RE: Blythe Energy Transmission Project Request for Approval of Insignificant Change

BLYTHE POWER PROJECT

**Request for Approval of
Insignificant Project Change
(99-AFC-8)**

**Blythe Transmission Line
Minor Route Realignment and Relocated Connection to
the Blythe Power Plant**

Figure 2-1. BEP Substation Layout

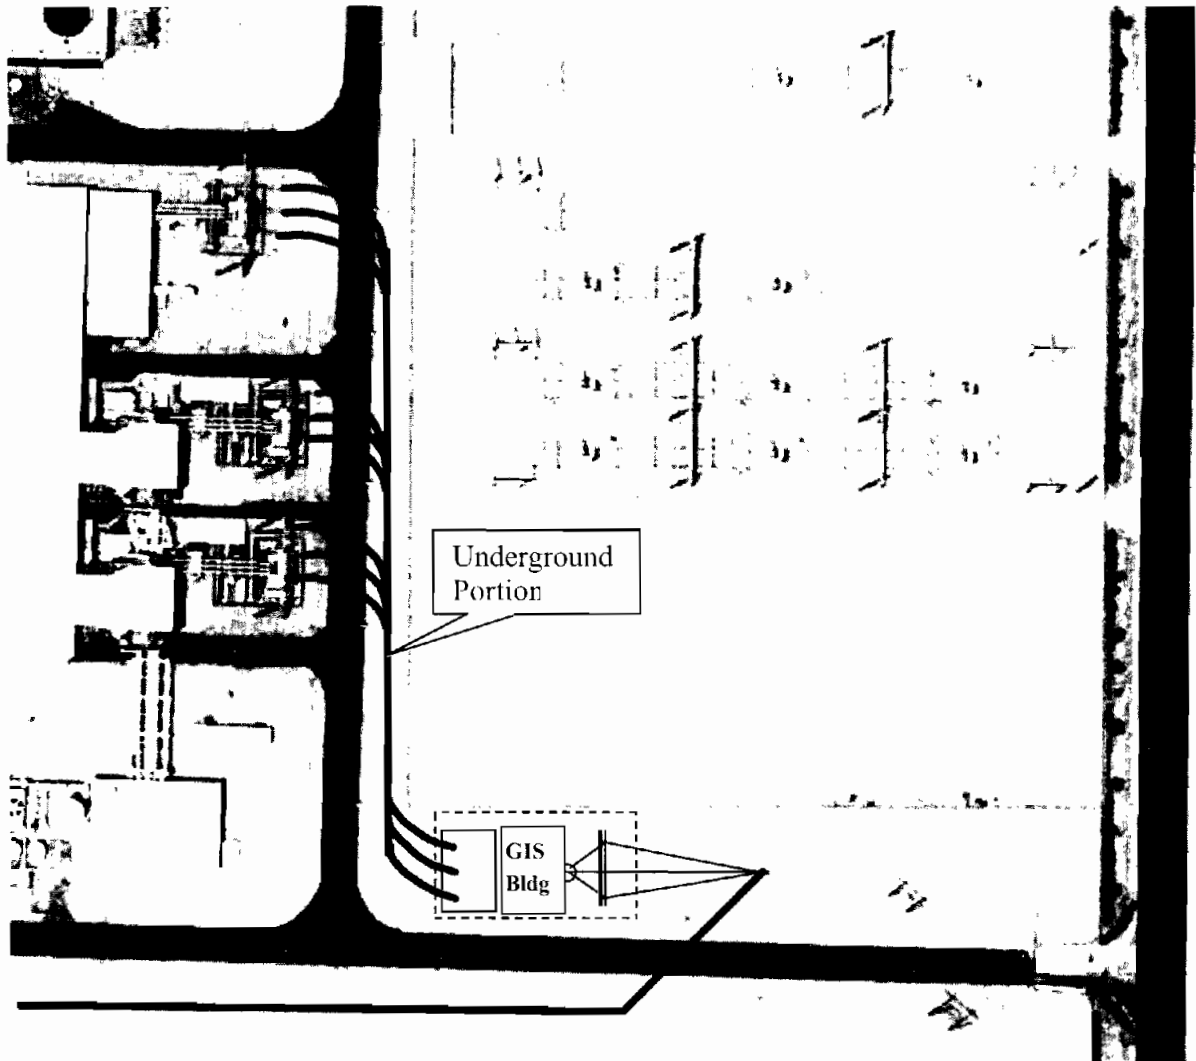
The three existing generator step-up (GSU) transformers at the Blythe Power Plant are currently energized at 161kV high side voltage and are connected to the WAPA owned Buck Substation. As part of the proposed modifications described above, the transformer high side voltage will be changed to 230kV and the current connection to the Buck Substation will be removed. Three new 230kV underground circuits will be installed from the existing GSU transformers over to a new 230kV gas-insulated switchyard that will be located on the south side of the Buck Substation in an already disturbed/graveled area (Figure 2-1). At the two existing combustion turbine generators (CTG) GSU transformer bays, the existing “A”-frame dead-end will be removed and a new “H”-frame will be installed to facilitate the connection to the 230kV underground terminations. At the steam turbine generator (STG) GSU transformer bay, a new H-frame tower will be installed and used in conjunction with the existing A-frame dead-end to facilitate the connection to the 230kV underground terminations. The new 230kV circuits will be routed south up the access road and then east into the new switchyard that will be located between the main plant south side access road and the existing Buck Substation (see Figure 2-1). An elevation drawing of the new switchyard is shown in Figure 2-2.

The new 230kV switchyard will be configured as a four breaker ring bus; three positions will be used to bring in the circuits from the GSU’s and the fourth position will be connected to a new 230kV overhead Blythe Energy transmission line.

Figure 2-3. Alternate Transmission Line Connection to BEP.

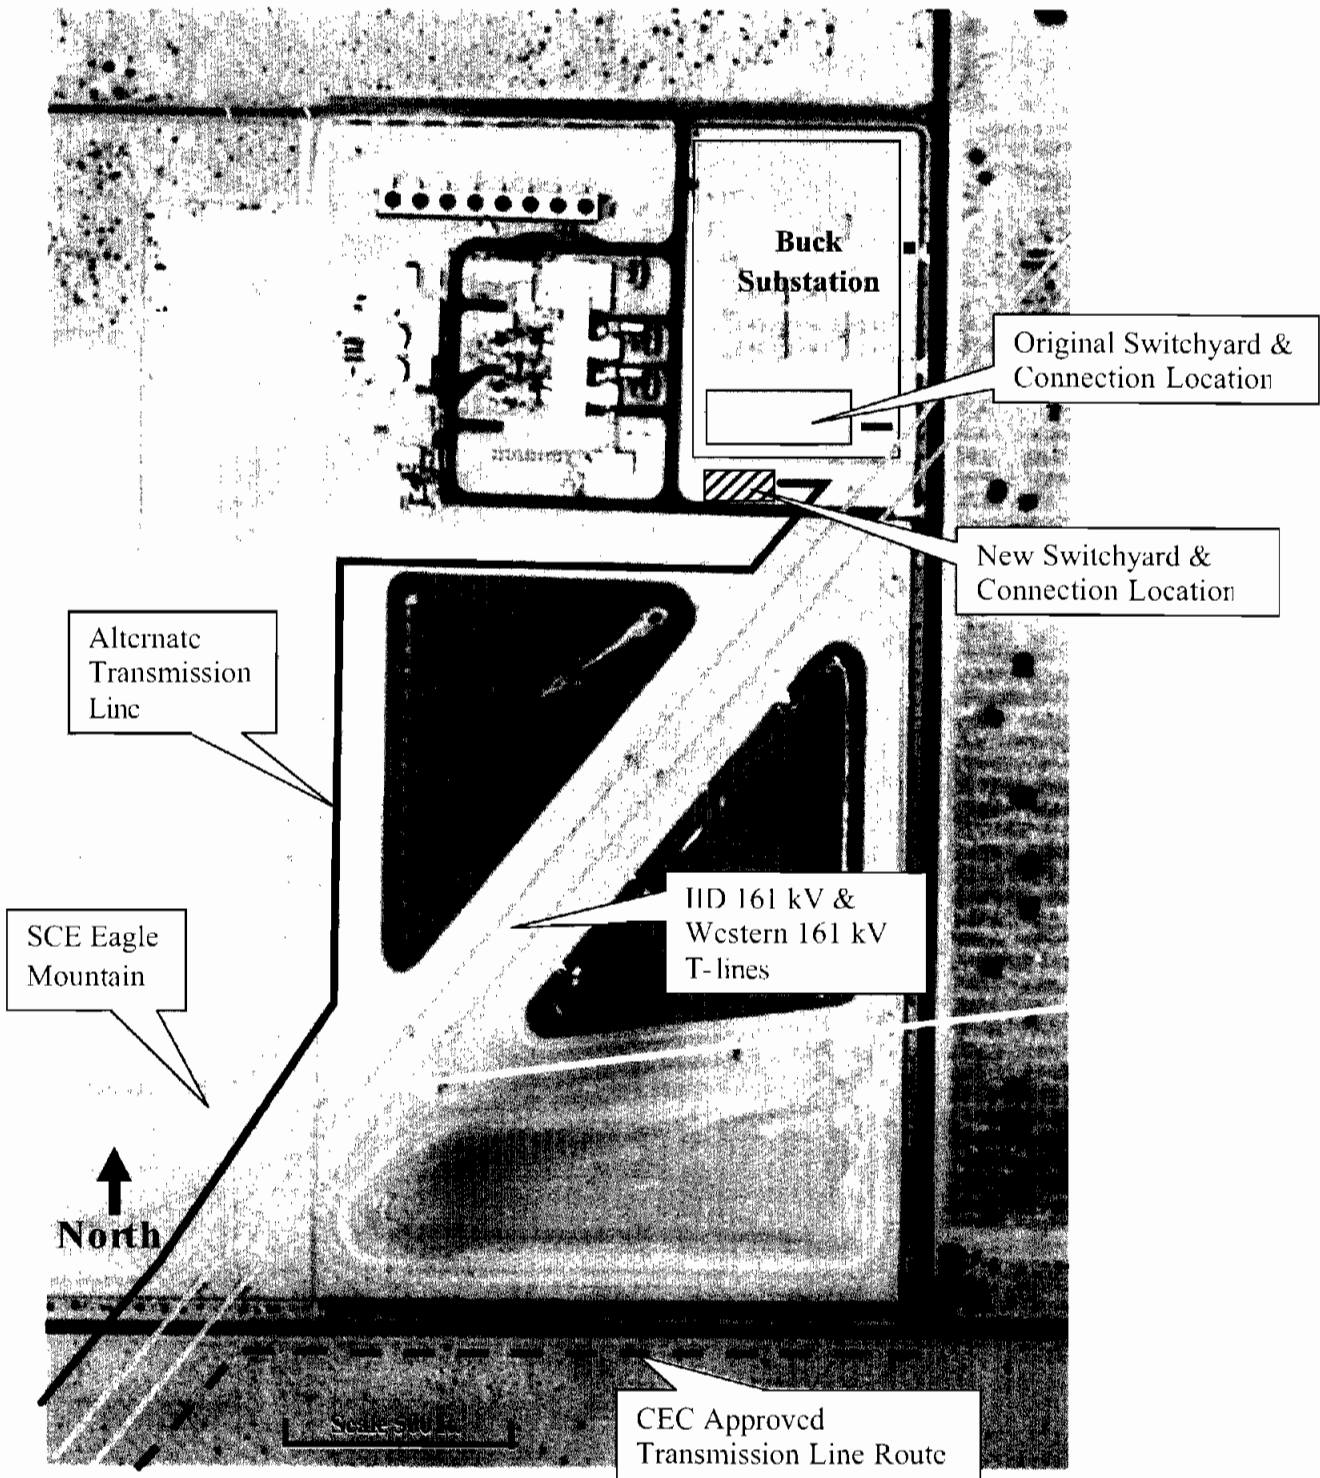
During the SCE new generation resource solicitation process it was determined that the transmission line intertie with the Buck substation would classify the electric output from the BEP as an import under WECC procedures. This classification was not consistent with the solicitation requirement for CAISO continuous dispatch of the generation resource. Therefore, Blythe Energy is seeking CEC approval of the proposed modification to the Buck-Julian Hinds transmission component such that this component interconnection would be revised from the Buck Boulevard substation to a new switchyard to be built at the BEP site (Figure 2-3). The CAISO has granted approval of this modified interconnection subject to the successful completion of the identified upgrades and mitigation measures.

Figure 2-6. Location of BTP ROW relative to SCE ROW on BLM and Private Lands.

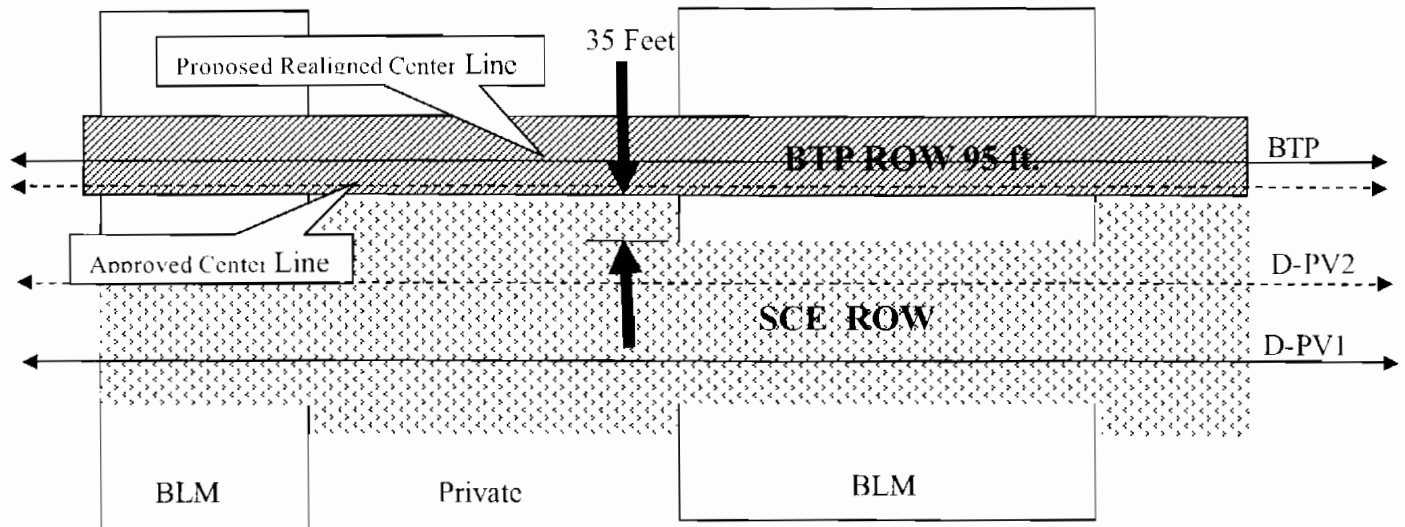
Figure 2-6 is a schematic illustration of the proposed realignment of the route that is 35 feet north of the original route from milepost 6.5 to 60.2. This realignment is necessary because the adjacent SCE ROW varies in width when passing from private to BLM lands. Approximately 271 poles will have to be relocated including the following pole numbers: 51-191, 239-282, and 312-402.

Adjustments to the pole locations from Milepost 6.5 to 60.2 are required where the alignment is adjacent to the SCE Devers Palo Verde 1 and 2 (DPV1 and DPV2). The SCE ROW varies in width when crossing BLM and private lands, a situation that was only recently discovered during the land acquisition process. In order for the BTP ROW to run straight on the north side of the SCE ROW when changing from private to BLM lands, the BTP ROW will be moved 35 feet north so that it is adjacent to the SCE ROW on private lands and 35 feet from the SCE ROW when on BLM lands. The new 95 foot ROW is within the corridor that was surveyed for biological, cultural, and other resources and no additional impacts are expected. Therefore the relocation of poles 35 feet to the north is considered a minor adjustment.

Figure 2-4 (Sheet 1 of 55)

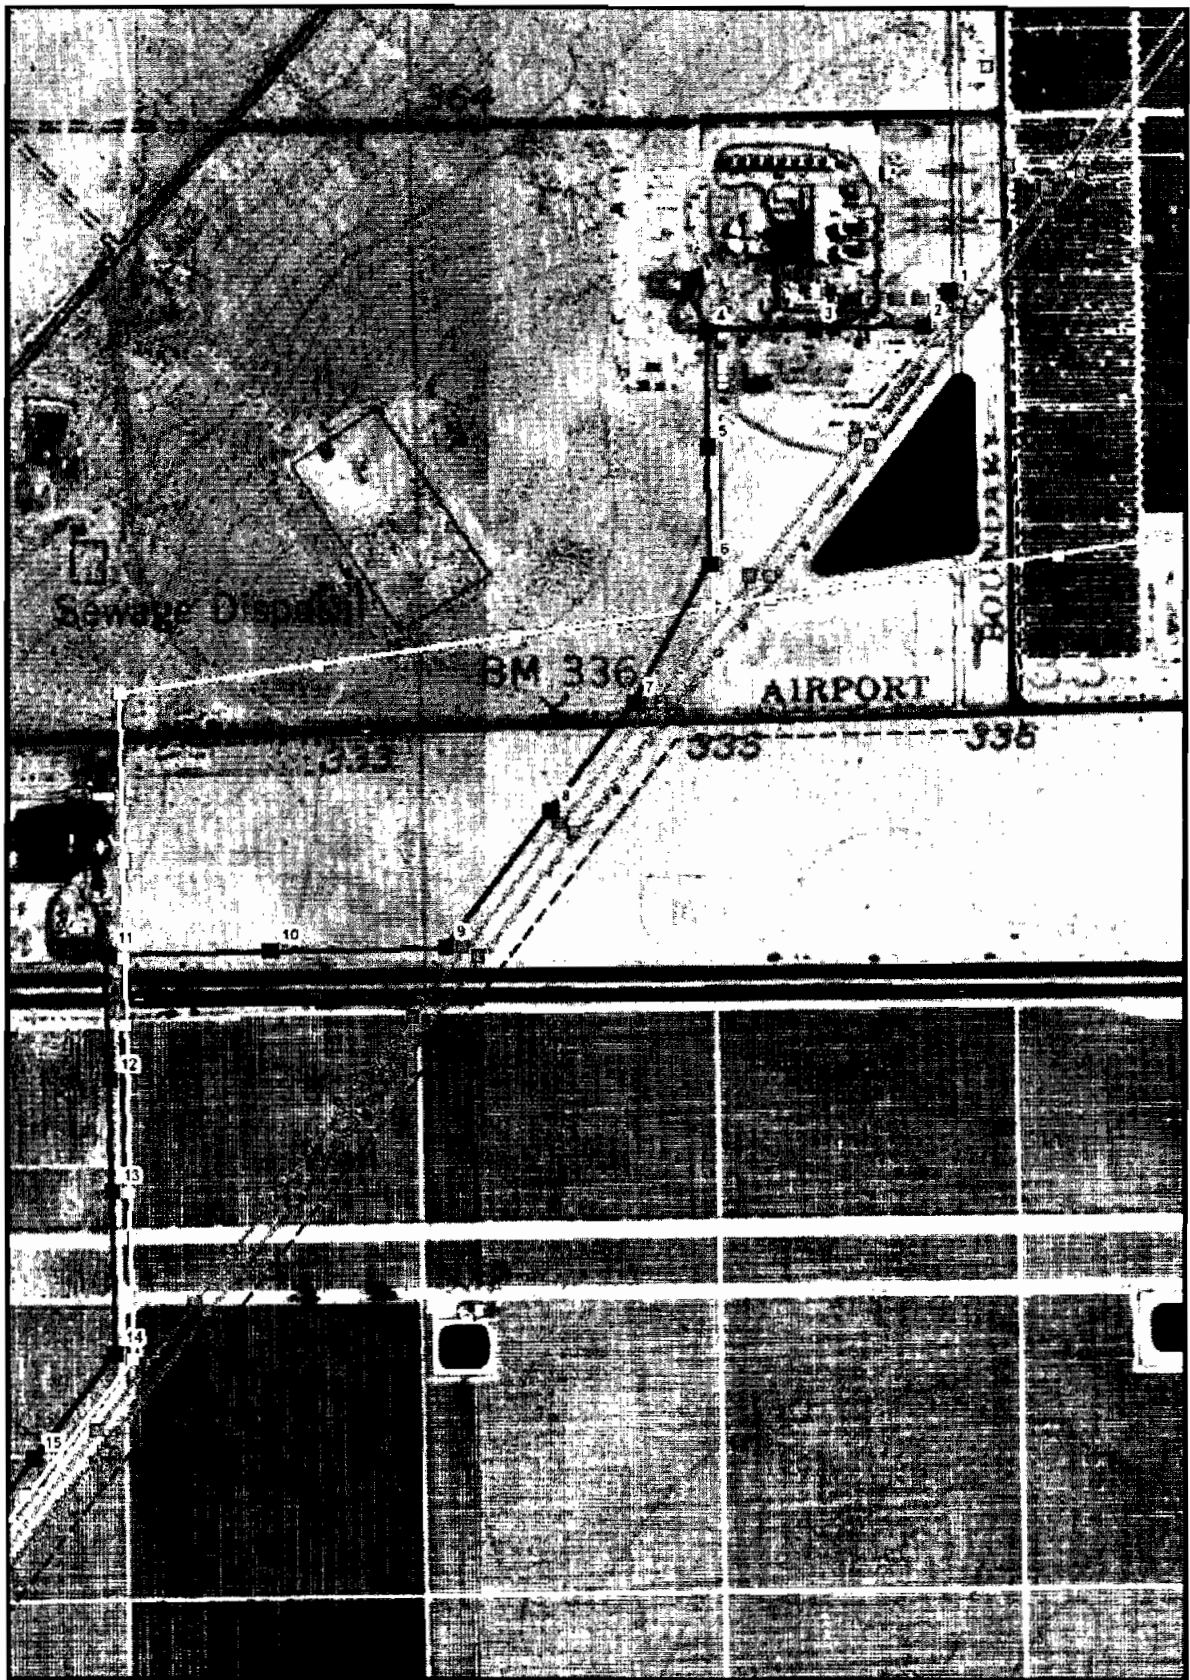
Figures 2-4 and 2-5 illustrate the original and proposed realignment from milepost 0.0 to 3.0. On BEP property, an alternate route connecting the new 230kV Blythe to Julian Hinds transmission line will be routed south from the switchyard, along the BEP western site boundary of the site following a route adjacent to the existing Western and IID transmission lines that cross the BEP site (see Figure 2-3). The approved route remains a possible option, depending on final engineering review. The realigned portion is from pole #1 to pole #25, a distance of approximately 3.0 miles. The realignment as proposed is adjacent to, and on the west side of, the existing IID and Western transmission lines along this portion of the route. South of pole #25, the realignment is the same as previously approved (CEC 2006). The approved transmission line alignment (Figures 2-4 and 2-5) crosses the existing Western Blythe-Knob and IID Blythe-Niland 161 kV transmission lines twice as well as crossing other lines close to the Buck Substation. Realignment of the transmission line using the proposed alternate route illustrated in Figure 2-3 will eliminate the crossings of the existing Western Blythe-Knob and IID Blythe-Niland 161 kV transmission lines and reduce the congestion of transmission lines immediately east of the Buck Substation. For this proposed alternative, two “H” frame structures will be required at pole locations # 6 and #7, (see Figure 2-4). Structures # 6 and 7 will be 120 feet tall.

The approved transmission line alignment (Figures 2-4 and 2-5) has two crossings of the existing Western Blythe-Knob and IID Blythe-Niland 161 kV transmission lines as well as other crossings of lines close to the Buck Substation. Realignment of the transmission line as illustrated in Figures 2-4 and 2-5 will eliminate the crossings of the existing Western Blythe-Knob and IID Blythe-Niland 161 kV transmission lines and reduce the congestion of transmission lines immediately east of the Buck Substation. For the section of transmission line that is parallel to the existing Western Blythe-Knob and IID Blythe-Niland 161 kV transmission lines, the realignment consists of placement of the line on the west side of these two lines, rather than on the east side. In addition to fewer transmission line crossings, the revised alignment has been requested by the property owner and will minimize interference with the ongoing citrus grove activities and result in reduced impacts to agricultural lands located south of I-10. This change is needed to reduce impact to a portion of the citrus groves and to coordinate alignment with other existing and proposed (Blythe II) transmission lines.

At the November 10, 2004, Informational Hearing and Site Visit, the Airport Manager/ Assistant City Manager for the City of Blythe was concerned that the height and original location of the nearest transmission line structures in the vicinity of the airport could potentially create a flight path problem and affect further airport development as described within the Airport Master Plan. The nearest pole was originally 2930 feet from the airport runway (Blythe Energy 2004). For the proposed realignment all of the poles are more distant (4297 feet at the closest) and the tallest pole (150 feet) is pole #6, which is located approximately 5644 feet from the end of the Blythe

Airport east-west runway (see Figure 2-4). The pole heights and locations for the proposed realignment were reviewed by the Airport Manager/ Assistant City Manager for the City of Blythe during a meeting on April 11, 2007 (R. Holt, personal communication). Blythe Energy has submitted the Federal Aviation Administration (FAA) Form 7460-1 Notice of Proposed Construction or Alteration for the pole locations closest to the airport and will submit the results of the FAA review to the CEC when it is received.

Figure 2-5 (Sheet 2 of 55)

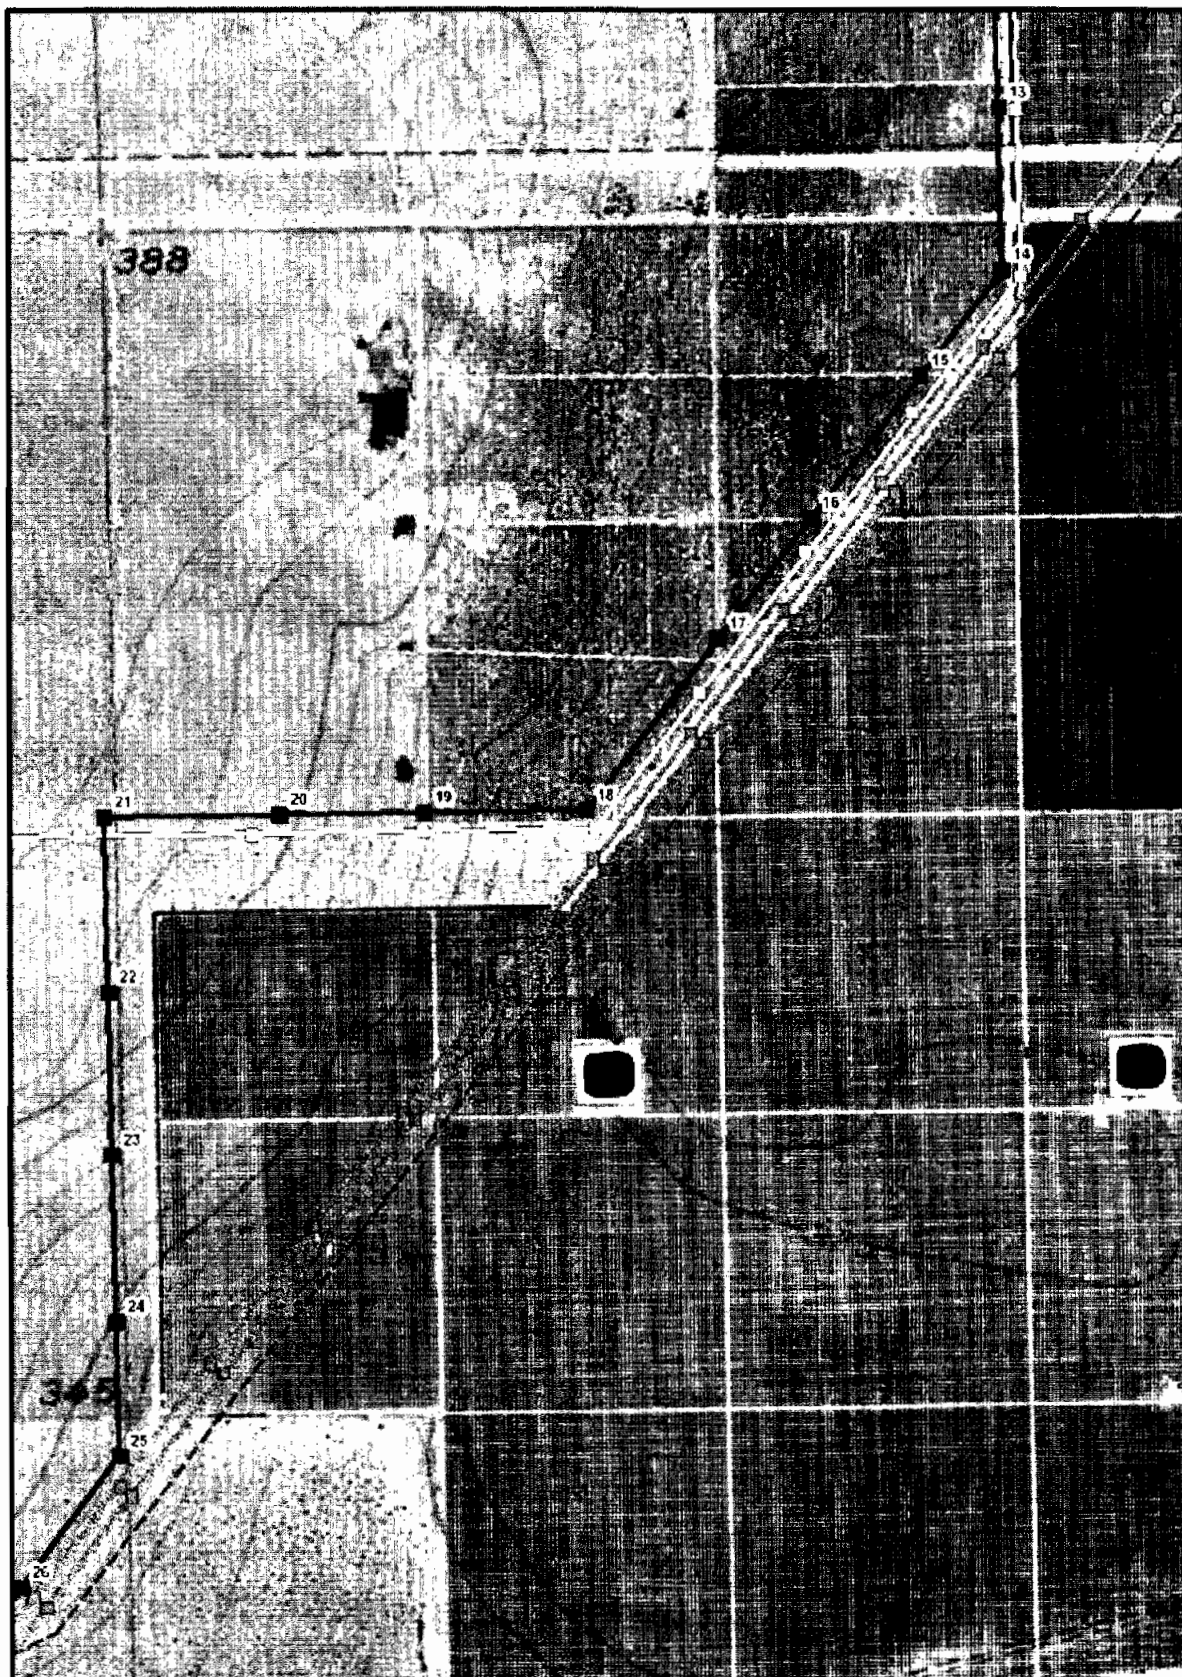
Figures 2-4 and 2-5 illustrate the original and proposed realignment from milepost 0.0 to 3.0. The realigned portion is from pole #1 to pole #25, a distance of approximately 3.0 miles. The alignment is now adjacent to, and on the west side of the existing IID and Western transmission lines along this portion of the route.

Figure 5-1. View looking east at the proposed switchyard location.

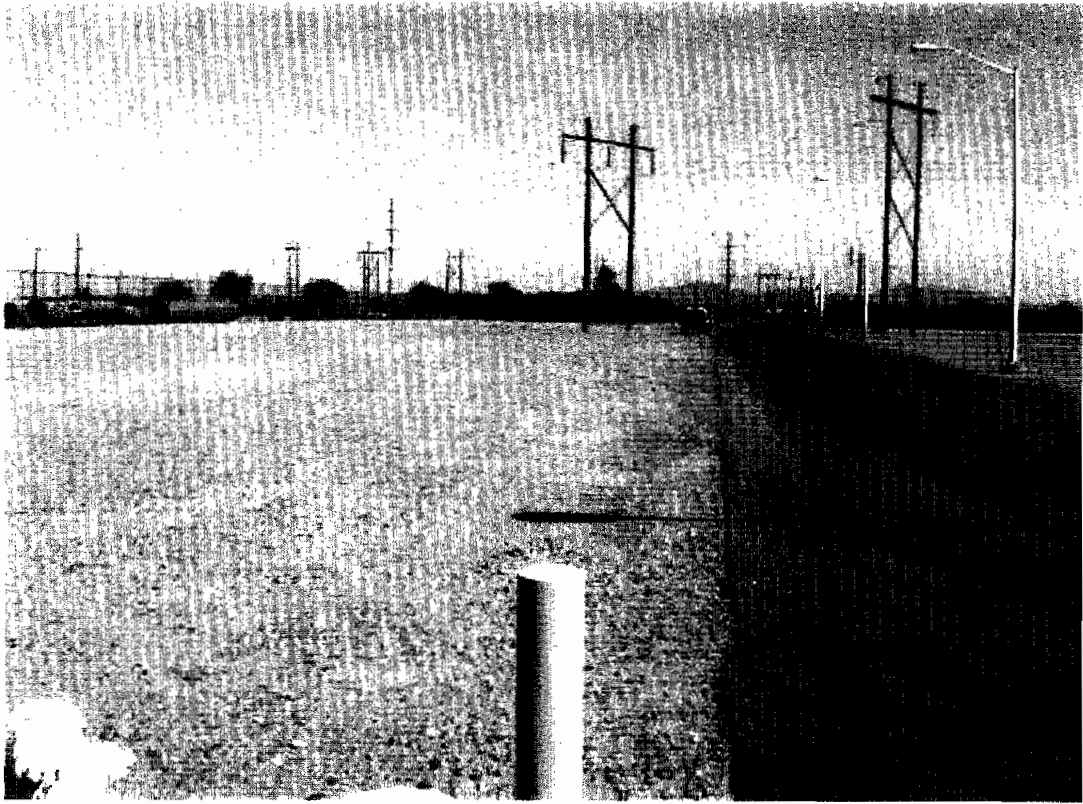
Like the approved Buck Substation location, the proposed switchyard is located in an already-disturbed, gravel-surfaced area (Figure 5-1) immediately adjacent to the Buck substation with no vegetation or natural habitat. The footprint of the new substation is approximately one-third the size of the footprint in the approved configuration.
